SUMMARY OF PROPOSED COMMITTEE DRAFT:

RESOLUTION 24-57

GRANTING A SPECIAL MANAGEMENT AREA (SMA) MAJOR PERMIT TO ALLOW THE ESTABLISHMENT OF AGRICULTURAL OPERATIONS AND CONSTRUCTION OF THREE ACCESSORY FARM DWELLINGS IN MOKULĒ'IA, O'AHU.

No. 24-57, CD1
PROPOSED

EXHIBIT I - 3.2-FOOT SEA LEVEL RISE EXPOSURE AREA WITH COASTAL EROSION PROJECTION

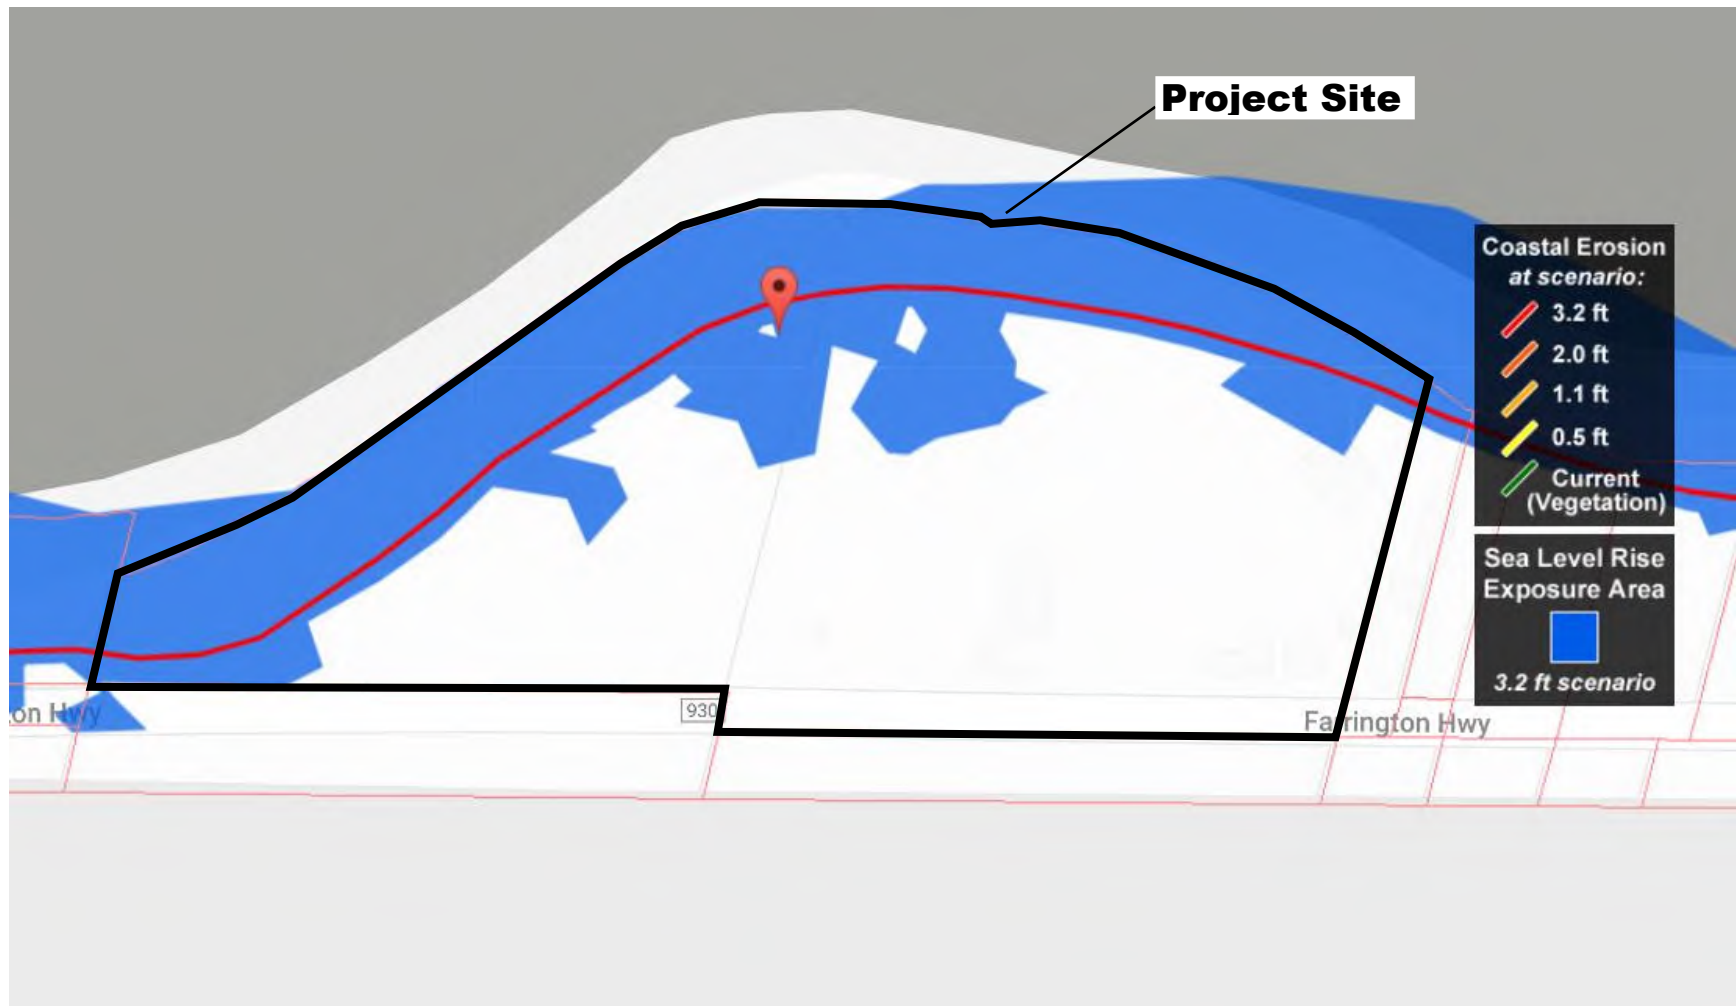
- F. Deletes Condition A, which would have required the accessory farm dwellings to be relocated outside of the 3.2-foot sea level rise exposure area ("SLR-XA"). Relalphabetizes subsequent conditions.

2. Adds a new Condition D.2 to provide for an acknowledgement that the makai portions and western edge of Tax Map Key 6-8-002:010 are projected to be impacted by 3.2 feet of sea level rise by the year 2100, and that portions of the proposed accessory farm dwellings are located within the 3.2-foot SLR-XA. Also provides that the landowners assume all risk and liability for any harm to or loss of life and property due to development within the SLR-XA.

impacted by 3.2 feet of sea level rise by the year 2100, and that portions of the proposed accessory farm dwellings are located within the 3.2-foot sea level rise exposure area ("SLR-XA"). The landowners agree to assume all risk and liability for any harm to or loss of life and property due to development within the SLR-XA."
